STAFFORD LOGISTICS CENTER DEVELOPMENT PLAN (FDP)

STAFFORD LOGISTICS CENTER DEVELOPMENT PLAN (FDP) - TOWNSHIP 4 SOUTH, RANGE 66 WEST OF THE CITY OF AURORA, COUNTY OF ARAPAHOE, STATE OF COLORADO

**STAFFORD LOGISTICS CENTER
PUBLIC IMPROVEMENT PLAN**
PLANNING AREA 1A
PIP PLAN

PUBLIC IMPROVEMENT PLAN NARRATIVE

ISSUE RECORD: 03/20/2020, where is the list of revisions?, SHEET NUMBER C1, XX OF XX

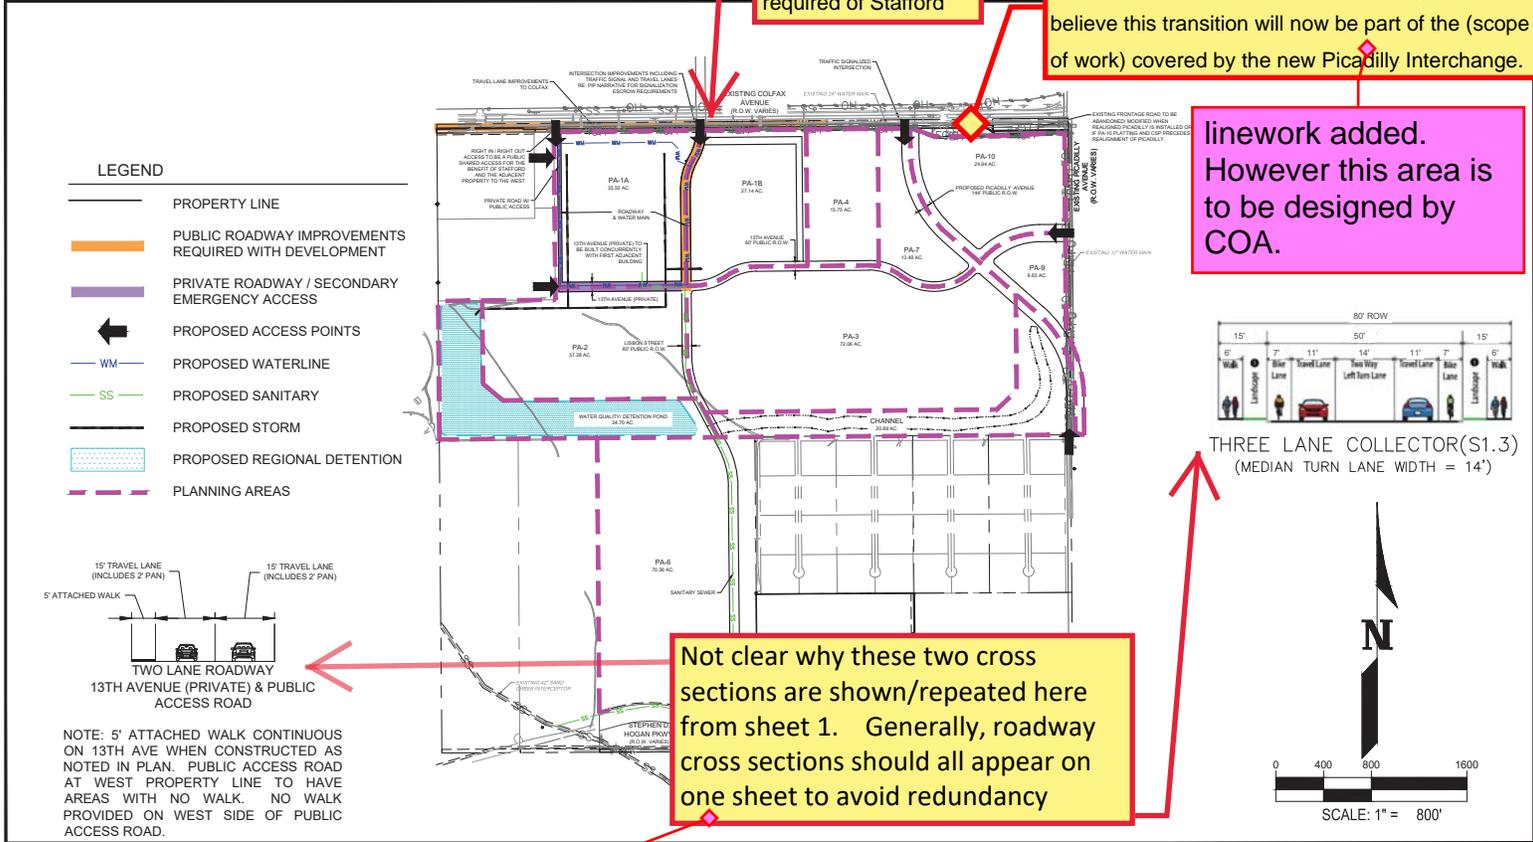
This is illegible. It appears to be table 2 / borrowed from the NEATS refresh of 2018. Without a narrative of explanation, it is not helpful to the (non-transportation) reader of this document. If it illustrates a ranges of LOS when thresholds warrant roadway improvements by Stafford, it belongs in the general notes.

These notes should be moved to a general note section - they obscure a rather important Roadway corridor flanking "PA-10"

Is it not premature to be showing conceptual site plans on PA 7, 9 & 10 - this is a zoning document.

A general note is recommended to advise of the removal of PAs 5 & 8 by this amendment.

Previously recommended that all roadway cross sections go onto a separate sheet. More space is needed for general notes, there are already too many side-bar notes added to the plan-map graphic.

Most often, a large set of plans would include a list-table of all sheets that comprise the full set. Otherwise the reader is unclear if they are examining the full picture. Pretty evident that sheets PA 5 & PA 8 have been removed - but how would one know?

Most outside sources are not familiar with Aurora's current zoning code. If this "Framework Development Plan" is C-1, are there more sheets to this set? The bottom sheet number does not offer us any hint if there are more sheets to this set. Attached to this is a Public Improvement Plan, that says sheet 1 of 9, and so forth. Is the PIP a subset of the FDP?

There are also center median improvements required of Stafford

Plan should show the planned transition of roadway from 4-lane highway to a 2-lane Frontage Road. We believe this transition will now be part of the (scope of work) covered by the new Picadilly Interchange.

we were asked by COA to provide this table. It will be moved to another sheet with the roadway sections. note added referring reader to report for use of NEATS table

notes revised to not obstruct roadway linework

I agree, linework removed

note added

language in callout revised. frontage only to be abandoned up to existing picadilly.

moved to separate sheet

sheet set added to table of contents in report. Cannot add index to cover sheet because this is part or another, larger document

XX OF XX REPLACED WITH CORRECT NUMBERS. SHEET INDEX ADDED TO REVISED PIP NARRATIVE

correct, callouts updated along with orange delineation

linework added. However this area is to be designed by COA.

SHEET
PA1A
Sheet 1 of 9

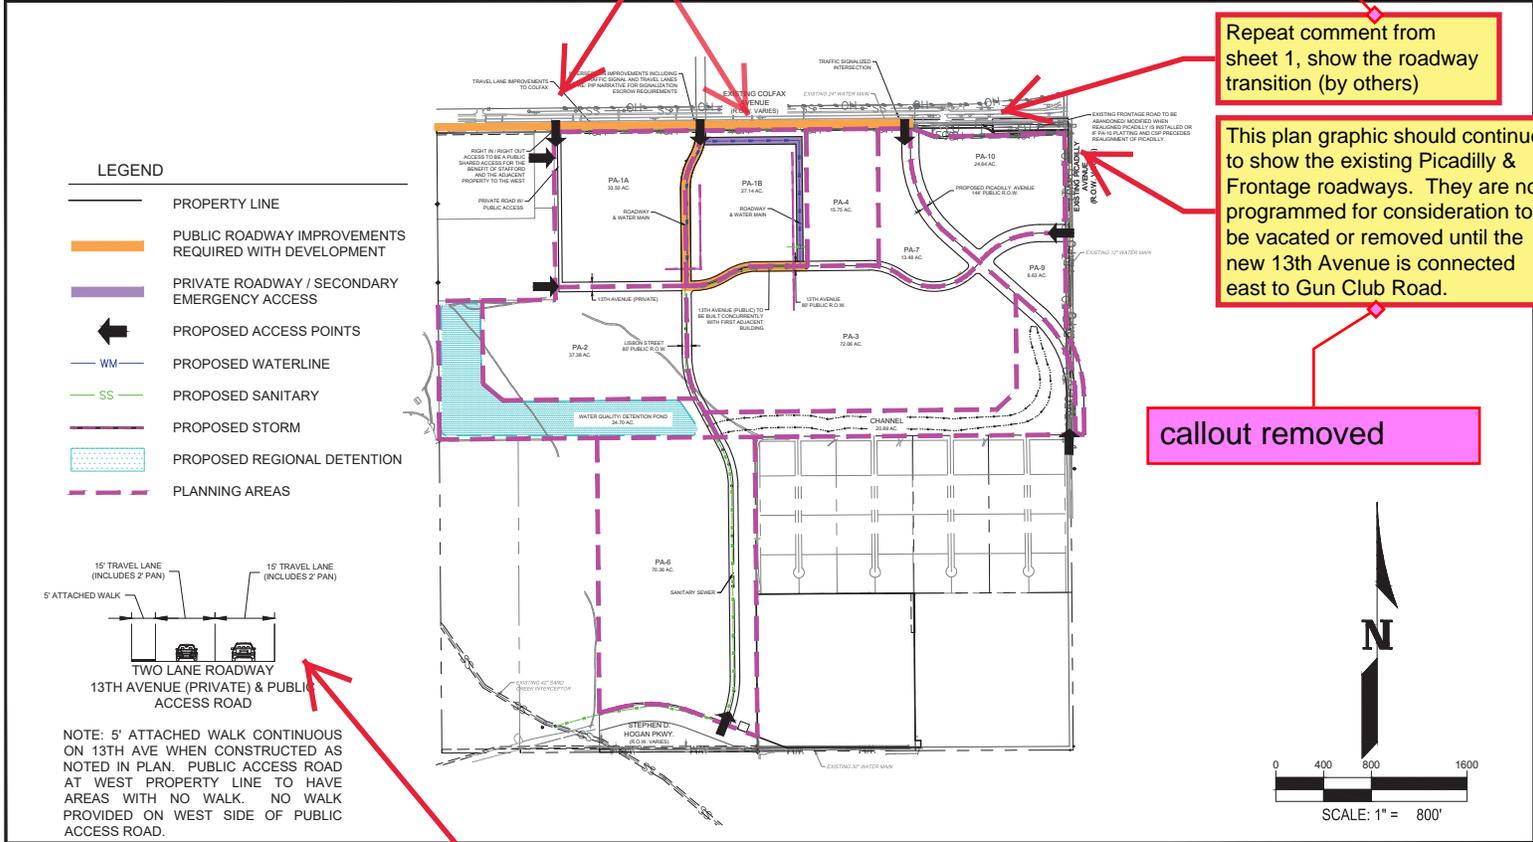
Not clear why these two cross sections are shown/repeated here from sheet 1. Generally, roadway cross sections should all appear on one sheet to avoid redundancy

Revision dates?

The scope-length of roadway improvements along Colfax with this phase looks consistent with CDOT-COA understanding

Repeat comment from sheet 1, show the roadway transition (by others)

This plan graphic should continue to show the existing Picadilly & Frontage roadways. They are not programmed for consideration to be vacated or removed until the new 13th Avenue is connected east to Gun Club Road.

they are shown on this sheet to show the differences between 13th avenue private and 13th ave public. Since Aurora has asked for the private 13th detail to be on this sheet i have left them here for PA1. they have been removed on all other sheets except the added detail sheet.

it appears you received our response to comments and not our most recent submittal. We will ensure CDOT recieves the correct documents in the future. Additional revision dates added as well

added

callout removed

SHEET
PA1B
Sheet 2 of 9

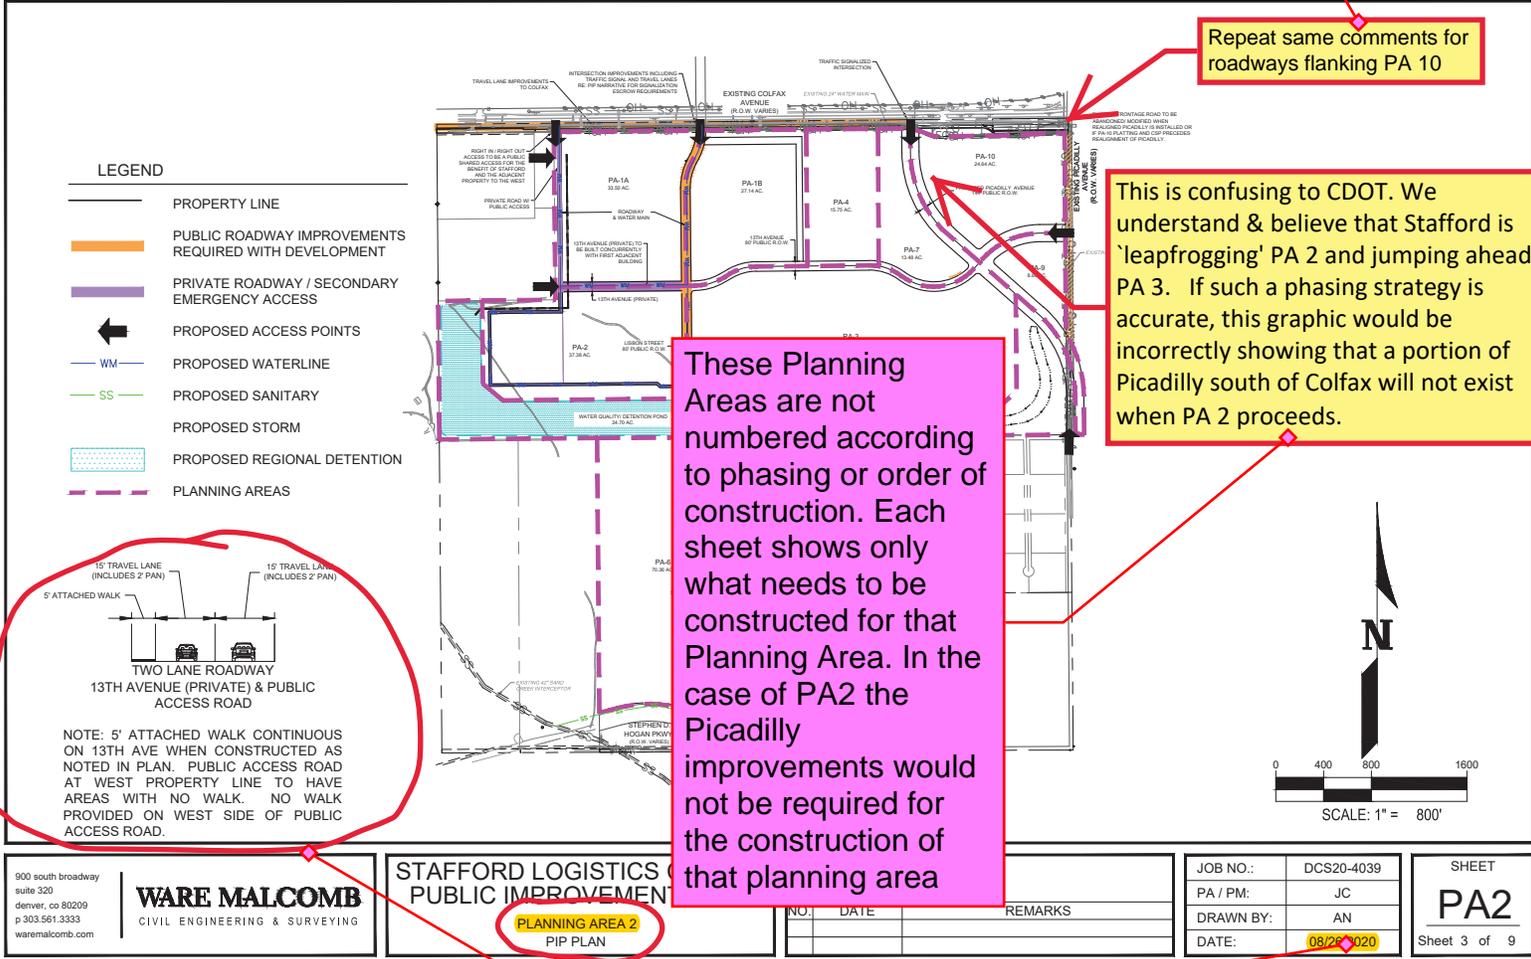
Repeat comment of redundancy. Suggest a separate sheet for all roadway cross sections.

Revision dates?

removed and added to detail sheet

revised

JOB NO.: DCS20-4039
PA / PM: JC
DRAWN BY: AN
DATE: 08/26/2020
SHEET PA2
Sheet 3 of 9

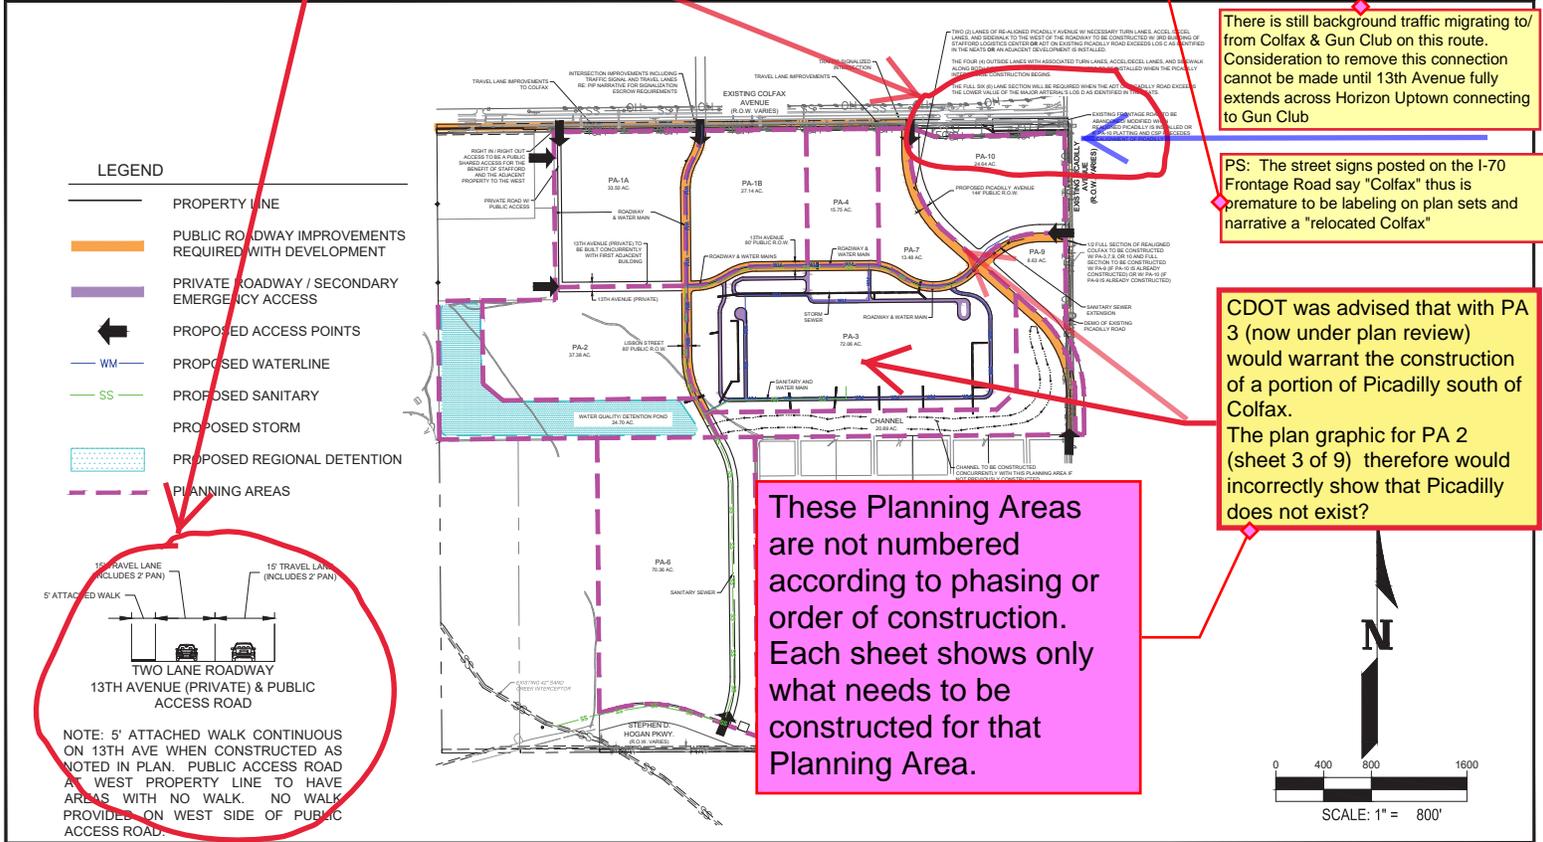
Repeat same comments for roadways flanking PA 10

This is confusing to CDOT. We understand & believe that Stafford is 'leapfrogging' PA 2 and jumping ahead to PA 3. If such a phasing strategy is accurate, this graphic would be incorrectly showing that a portion of Picadilly south of Colfax will not exist when PA 2 proceeds.

These Planning Areas are not numbered according to phasing or order of construction. Each sheet shows only what needs to be constructed for that Planning Area. In the case of PA2 the Picadilly improvements would not be required for the construction of that planning area

revised

colfax frontage would only be removed from realigned picadilly to existing picadilly. callout revised

addressed

revised to say 13th avenue per emails

SHEET
PA3
Sheet 4 of 9

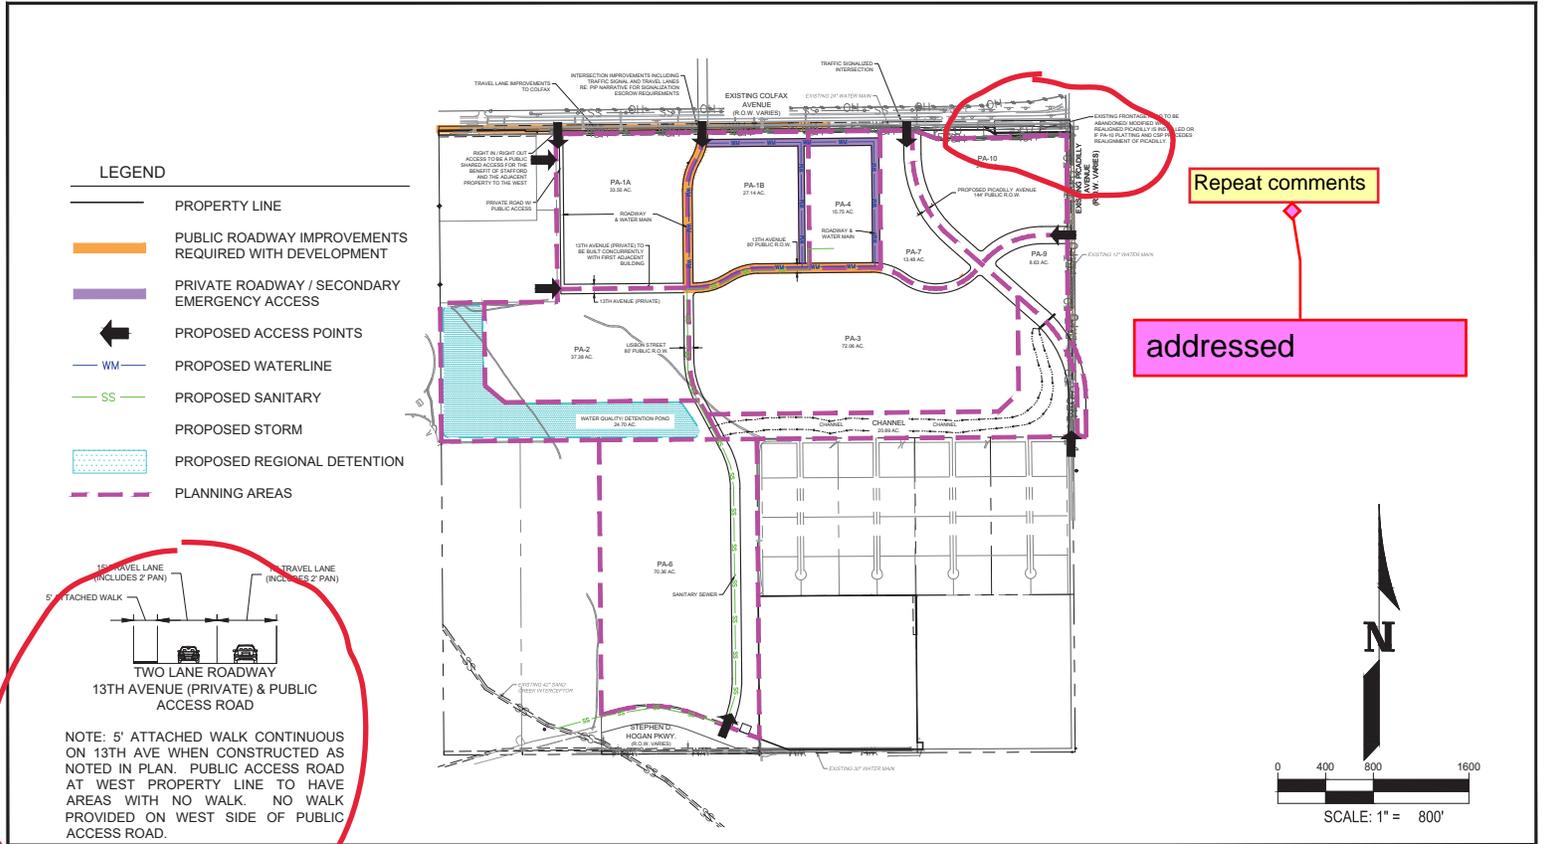
Repeat previous comments

There is still background traffic migrating to/from Colfax & Gun Club on this route. Consideration to remove this connection cannot be made until 13th Avenue fully extends across Horizon Uptown connecting to Gun Club

PS: The street signs posted on the I-70 Frontage Road say "Colfax" thus is premature to be labeling on plan sets and narrative a "relocated Colfax"

CDOT was advised that with PA 3 (now under plan review) would warrant the construction of a portion of Picadilly south of Colfax. The plan graphic for PA 2 (sheet 3 of 9) therefore would incorrectly show that Picadilly does not exist?

These Planning Areas are not numbered according to phasing or order of construction. Each sheet shows only what needs to be constructed for that Planning Area.

SHEET
PA4
Sheet 5 of 9

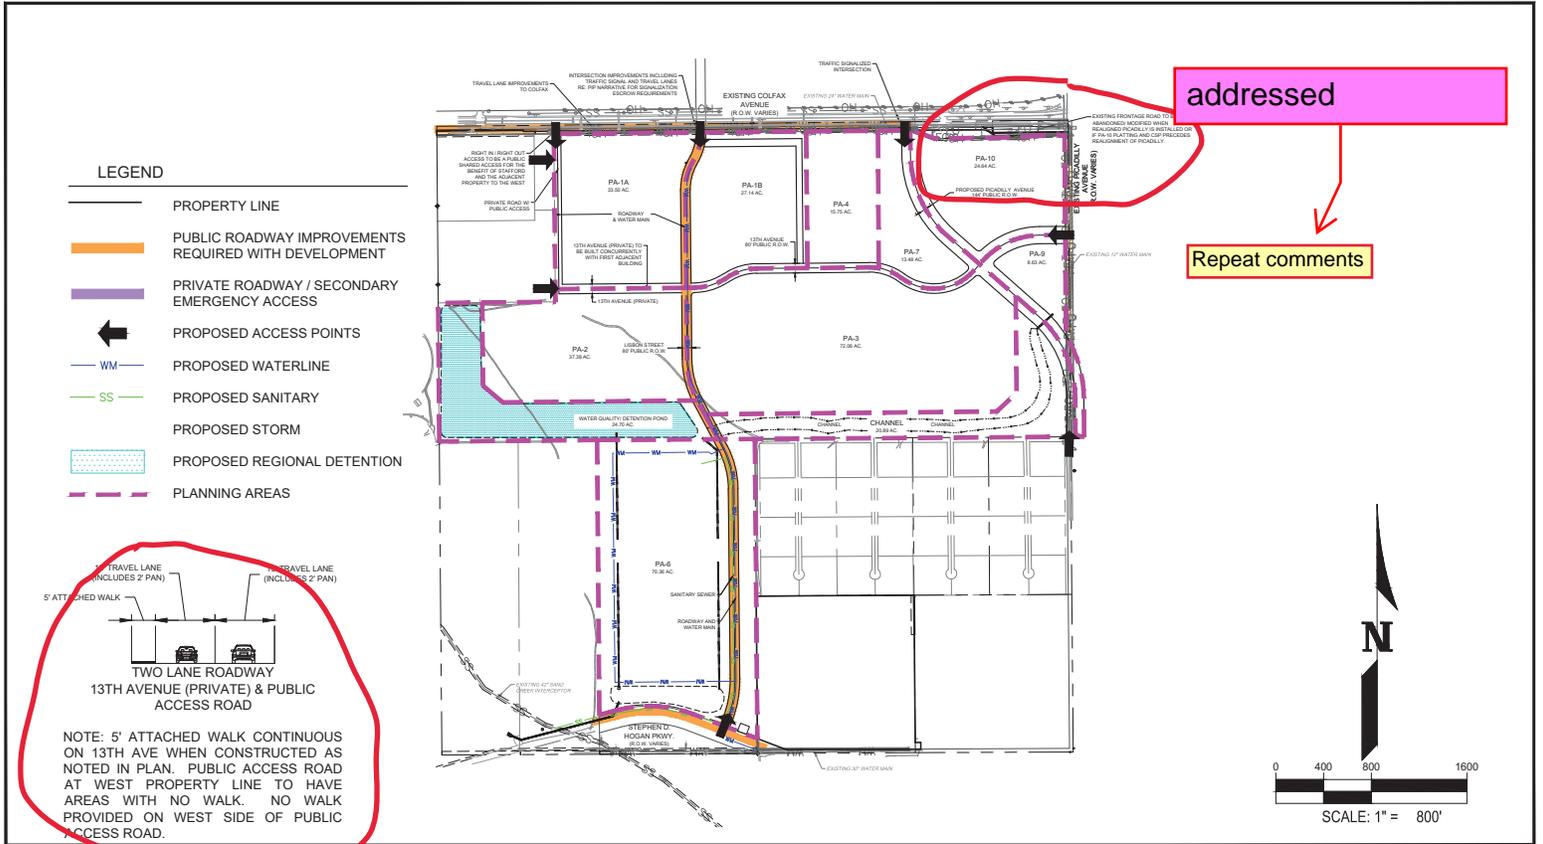
Repeat comments

addressed

addressed

SHEET
PA9
Sheet 8 of 9

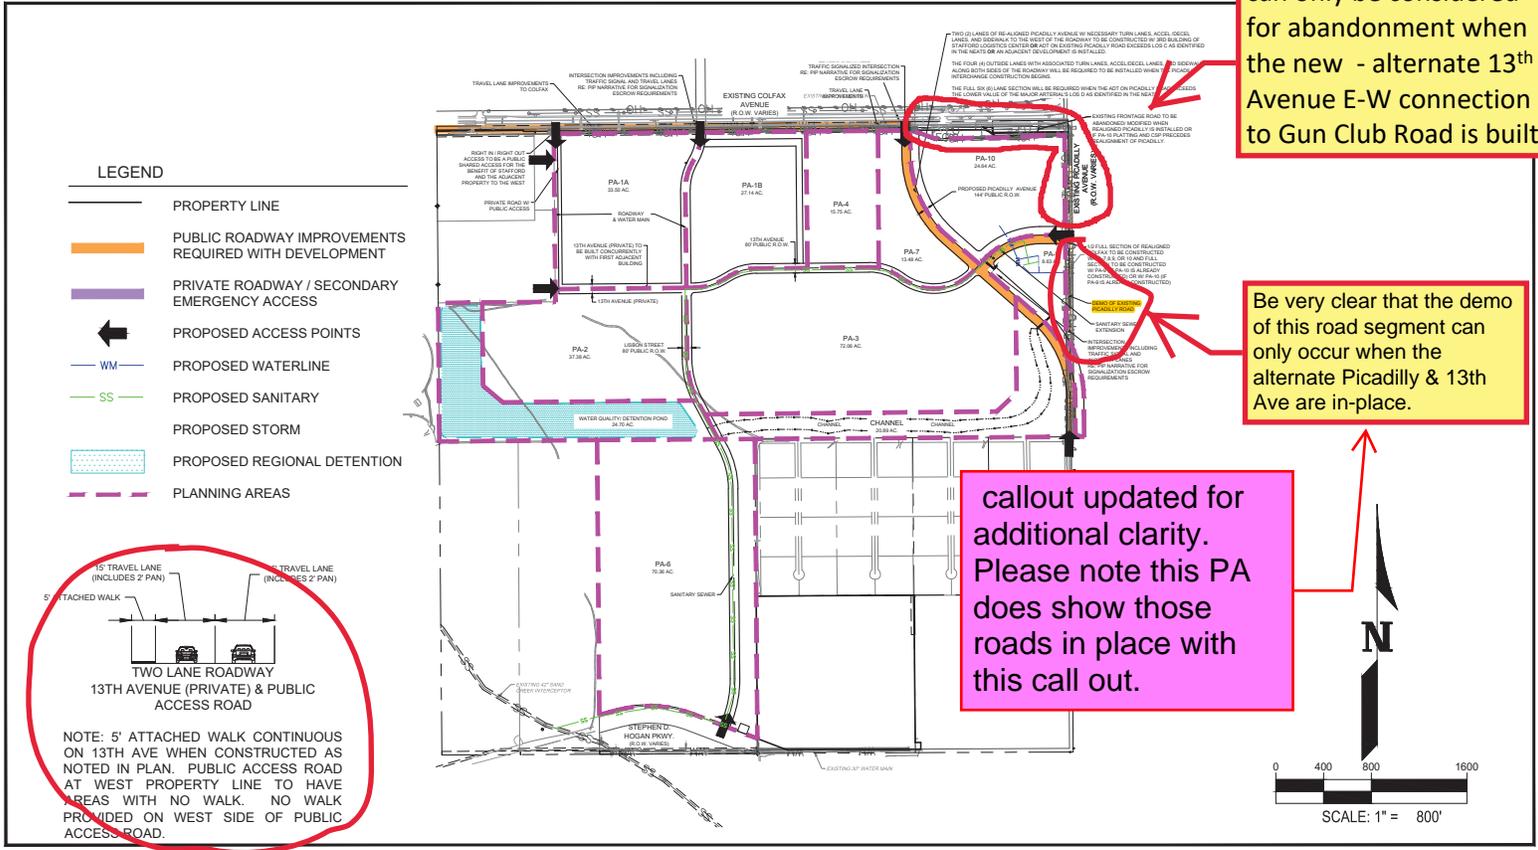
To clarify again, this segment of existing Picadilly & Frontage Road can only be considered for abandonment when the new - alternate 13th Avenue E-W connection to Gun Club Road is built.

Be very clear that the demo of this road segment can only occur when the alternate Picadilly & 13th Ave are in-place.

roadway to be abandoned only up to existing picadilly rd. Callout updated

callout updated for additional clarity. Please note this PA does show those roads in place with this call out.
